ENVIRONMENTAL
PROTECTION

July 7, 1999

Re: Shallow Ground-Water Sampling Results and Addendum to Additional Ground-Water Investigation Workplan, 1600 63rd Street, Emeryville, California

Figure 1: Site Map Showing Proposed Sampling Locations

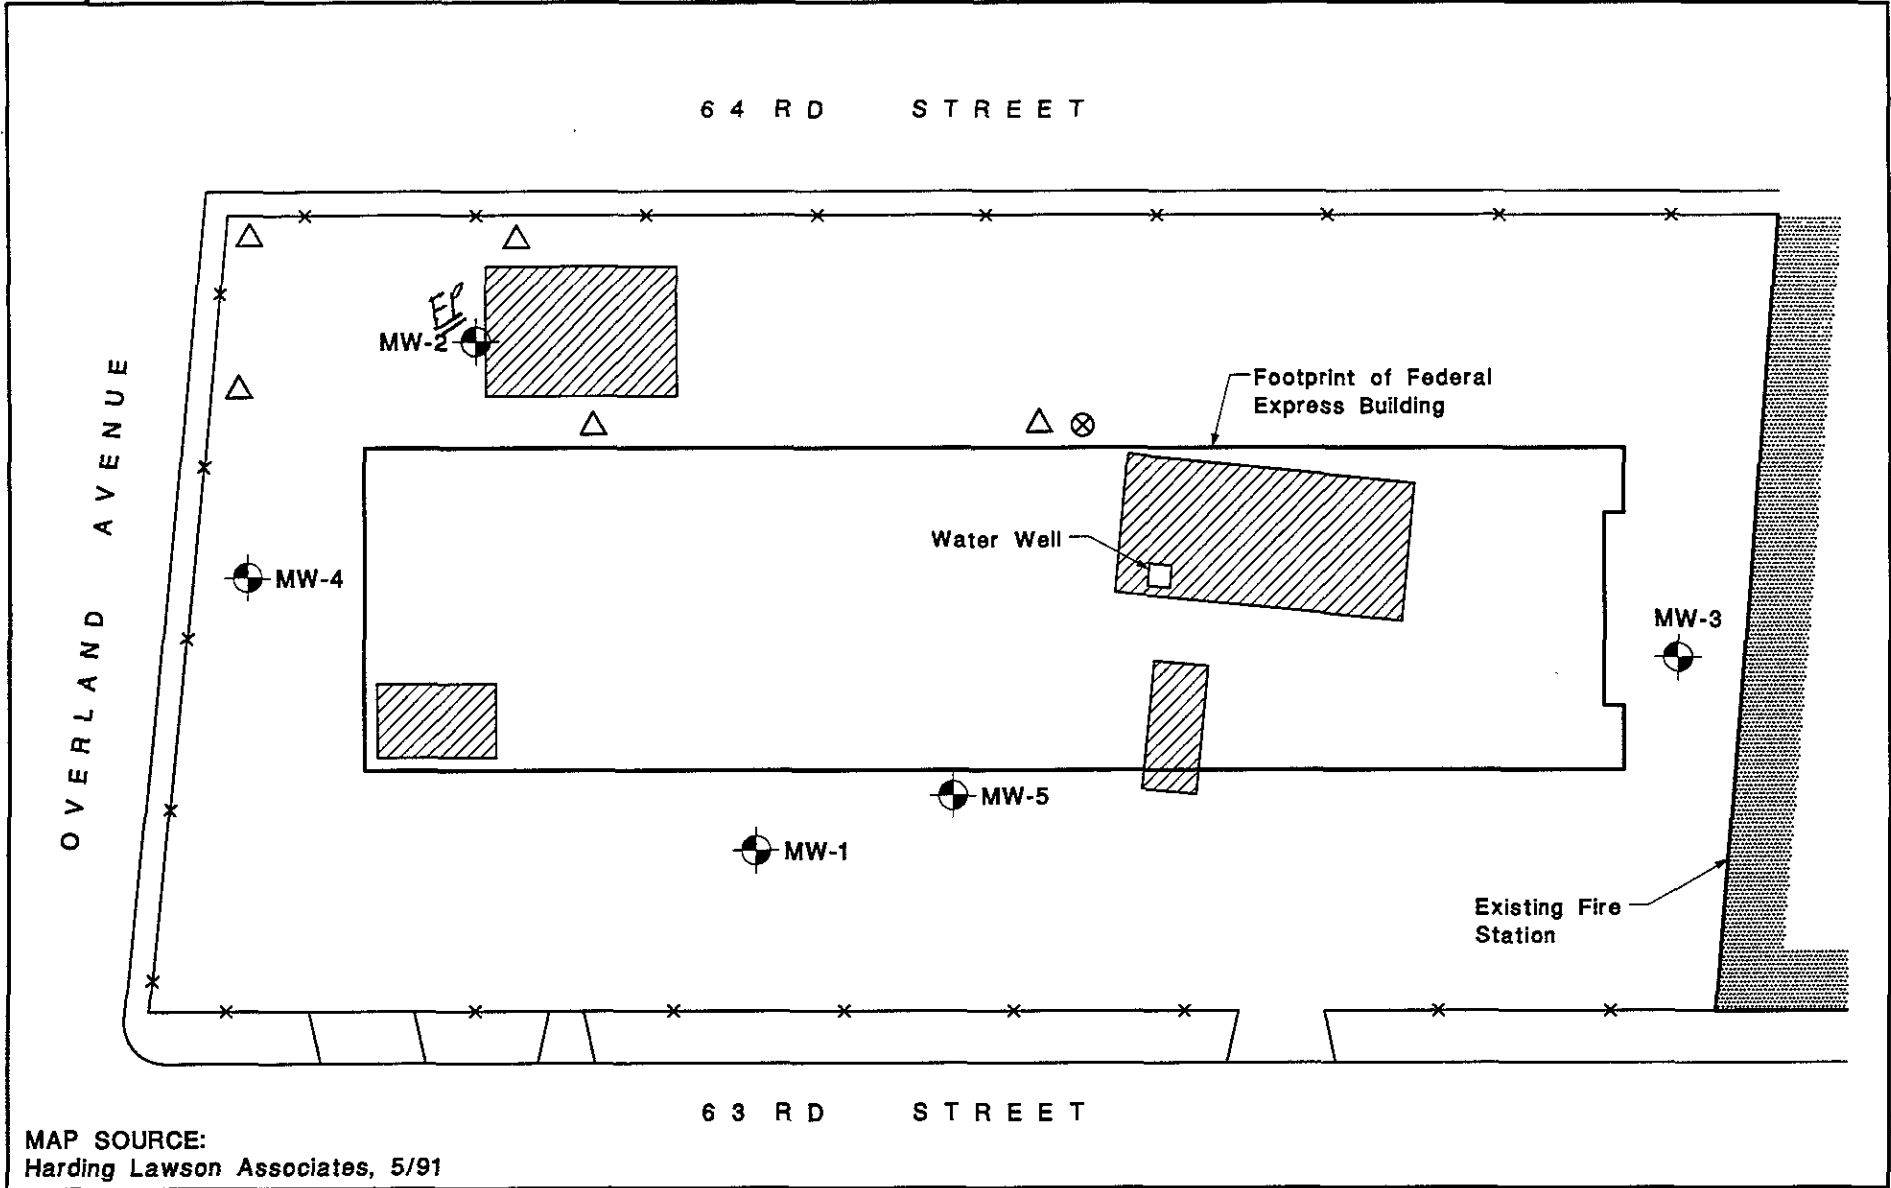
Based on the results of recent ground-water sampling indicating floating product in well MW-2, additional shallow ground-water investigations are recommended to assess the extent of petroleum hydrocarbons and floating product in the vicinity of well MW-2. Additional investigations are proposed to collect ground-water grab samples from 5 locations adjacent to well MW-2 (Figure 1). The sampling locations shown in Figure 1 are contingent upon access limitations (i.e., site features, utilities) and final locations may be moved to the closest accessible location. The ground-water samples will be submitted

The ground-water samples are proposed to be collected from temporary borings drilled using portable direct push or Geoprobe™ drilling equipment. Based on previous data collected in the Site vicinity, we anticipate that the depth to ground water at the Site is approximately 5-feet below grade. Ground-water grab samples will be collected from borings drilled to approximately 5- to 10-feet below the ground-water surface (i.e., 10- to 15-feet below grade). Ground-water grab samples will be collected from the borings using a Teflon or stainless steel bailer lowered into temporary PVC well casing installed in the borehole. The temporary PVC well casing will be screened across the ground-water surface and will stand overnight prior to sampling to allow product to enter the casing, if present. The ground-water samples will be placed in a chilled cooler immediately after collection for transport to the laboratory. In the event that a ground-water grab sample cannot be collected from the boring due to the presence of low permeability sediments, a soil sample will be collected during drilling from slightly below the soil/ground-water interface and sent to the laboratory for petroleum hydrocarbon analysis. After collecting the sample, the borehole will be sealed with a bentonite-grout mix and the ground surface restored using replacement materials (i.e., asphalt patch, concrete).

The additional investigations are recommended to be conducted prior to conducting the CPT deep ground-water investigation described in the Workplan. Conducting the recommended additional investigations will provide data on the shallow ground-water quality in the area of the proposed CPT sampling location (Figure 1).
